# Coastal Access – Cremyll to Kingswear

## Representations on CKW 5: Mothecombe Beach to Avon Estuary and Natural England's comments

June 2020

## Representations on CKW 9: Torcross to Kingswear and Natural England's comments

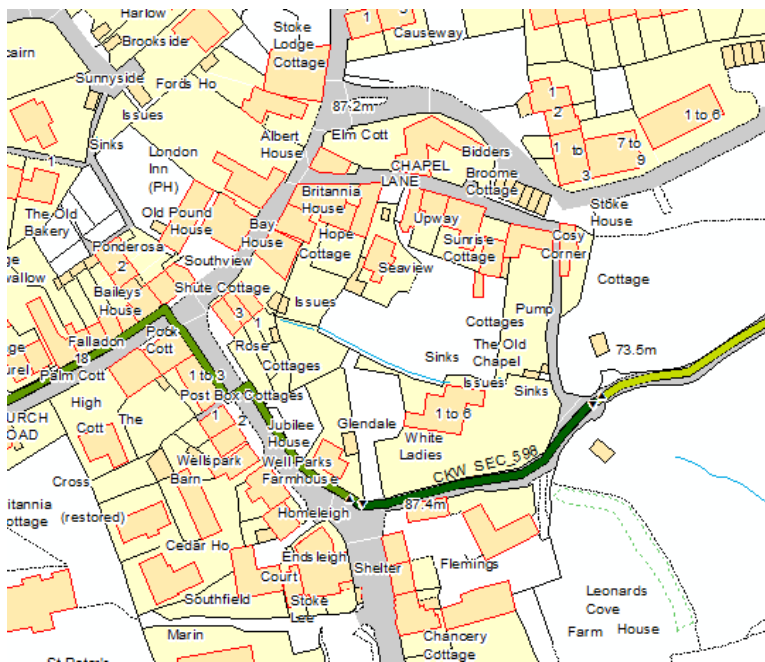
One of the representations suggests aligning the trail along a route parallel to the western part of Redlap Lane, along the seaward side of the roadside hedge – to allow walkers to use an off-road, traffic free path. However, we opted for the proposed route along Shady Lane because:

- it provides a better walking experience because it is closer to the sea with more coastal views and coastal sounds, particularly from the fields between Shady Lane and Redlap Lane;
- it reduces the potential impact on the farmland in the coastal margin – if the route of the ECP were to follow a parallel route adjacent to Redlap Lane, a significantly larger area of farmland would fall within the coastal margin; and
- it addresses the land use and land management requirements of the owners of the farmland through which the trail passes.
